PERCH CREEK LANDING SUBDIVISION

APPLICATION NUMBER 15 DATE February 3, 2011

REQUEST Subdivision

DETAIL SITE PLAN

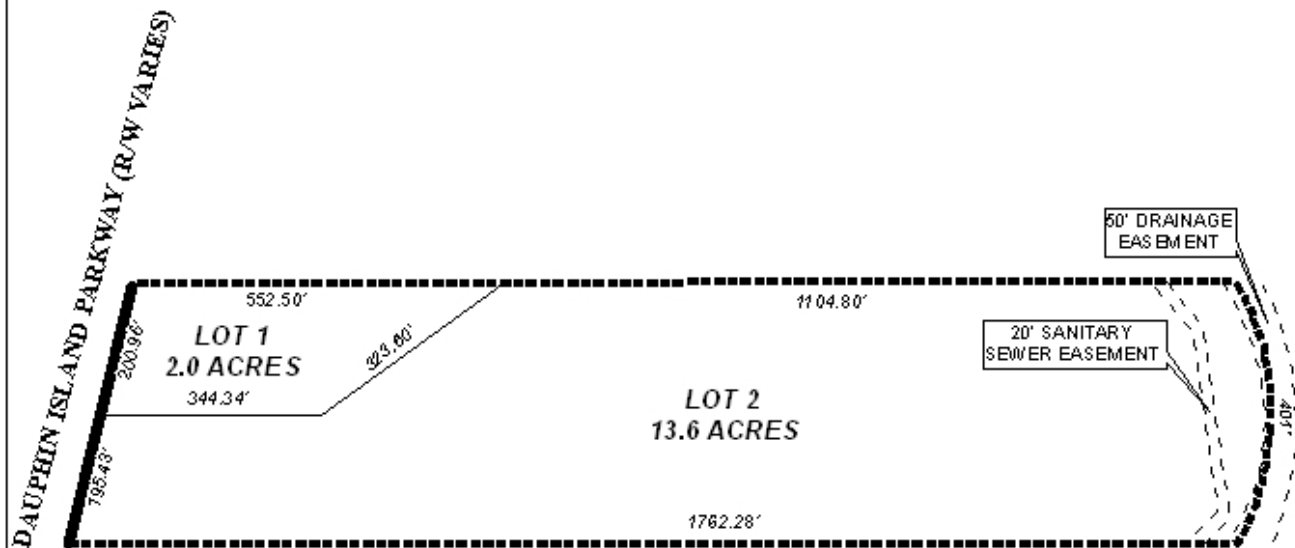
Engineering Comments: Show Minimum Finished Floor Elevation on each lot on Plat. Also show location of wetlands. There is to be no fill placed within the limits of the flood plain without providing compensation. No work shall be permitted within any wetlands without approval from the Corps of Engineers. Must comply with all storm water and flood control ordinances. Any work performed in the right of way will require a right of way permit in addition to any required land disturbance permit.

The proposed lots, as depicted, meet the minimum size and frontage requirements as regulated by the Subdivision Regulations. The lot area size is depicted on the plat in acres, and this should be revised to also depict the lot area size in square feet on the Final Plat, if approved. The 25-foot minimum building setback line is not depicted, and this should also be shown along all public street frontages on the Final Plat, if approved.

The site fronts Dauphin Island Parkway, a planned major street as shown on the Major Street Plan component of the Comprehensive Plan, to the East. The required right-of-way as per the Plan is 100 feet. The actual right-of-way width is not shown on the preliminary plat, and as such, dedication to provide 50 feet from the centerline of Dauphin Island Parkway should be required.

Dauphin Island Parkway is a major street and a State Highway. As such access management is a concern. Each lot should be limited to one curb cut each, with the size, design, and exact location of all curb cuts to be approved by Traffic Engineering and ALDOT and conform to AASHTO standards.

- 1) dedication sufficient to provide 50 feet from the centerline of Dauphin Island Parkway;
- 2) depiction of the 25-foot minimum building setback line along all public rights-of-way on the Final Plat;

- 3) depiction of the lot area, in square feet, on the Final Plat;
- 4) placement of a note on the Final Plat stating that each lot is limited to one curb cut to Dauphin Island Parkway, with the size, design, and exact location of all curb cuts to be approved by Traffic Engineering and ALDOT and conform to AASHTO standards;

- 5) compliance with Engineering comments: *“Show Minimum Finished Floor Elevation on each lot on Plat. Also show location of wetlands. There is to be no fill placed within the limits of the flood plain without providing compensation. No work shall be permitted within any wetlands without approval from the Corps of Engineers. Must comply with all storm water and flood control ordinances. Any work performed in the right of way will require a right of way permit in addition to any required land disturbance permit;”*
